S. S. PAPADOPULOS & ASSOCIATES, INC.
ENVIRONMENTAL & WATER-RESOURCE CONSULTANTS

Subject: Peer review of Duntroon Quarry hydrogeologic modelling: Report #2

Figure 1. Comparison of hydraulic conductivities from packer testing and model calibration

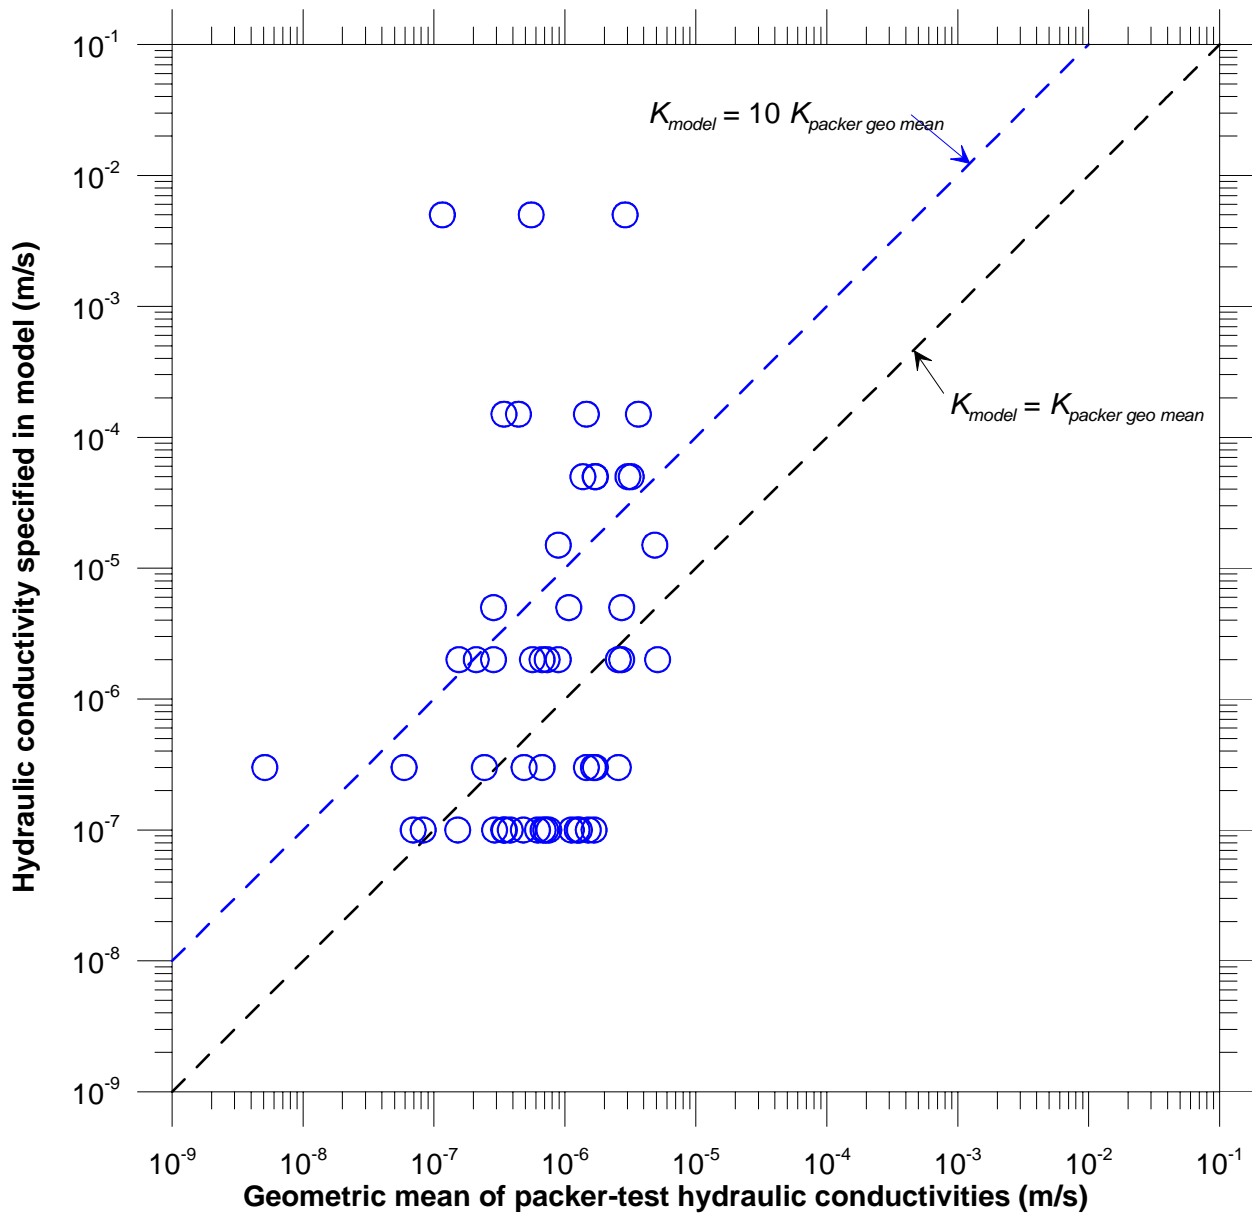
3. Page 4: Although model preprocessors generally require hydraulic conductivity as input, MODFLOW really works with transmissivities. It is our understanding that the transmissivities specified for each model layer were in part constrained by the products of the model layer thicknesses and the geometric means of the transmissivities estimated from packer tests conducted over the elevations corresponding to the layers. In our opinion, this may not be appropriate, as the inflows to the existing quarry and the proposed expansion will be dominated by the most transmissive intervals. The geometric mean tends to “suppress” the highest values. In our opinion, it is generally more appropriate to constrain the transmissivities of the layers with the cumulative transmissivities of the packer tests at each location.

We raise this point because at first glance it appears that there is a weak correlation between the hydraulic conductivities specified for each layer in the calibrated model and the corresponding geometric means. As shown in Figure 1, there does not appear to be a systematic relationship between the results of the packer testing and the conductivities estimated through model calibration. In particular, the model conductivities do not appear to be approximately an order-of-magnitude higher than the estimates derived from the packer testing as is suggested in the responses. Figure 1 was assembled from the information provided in JHL’s response to comments, Tables 1 through 9.
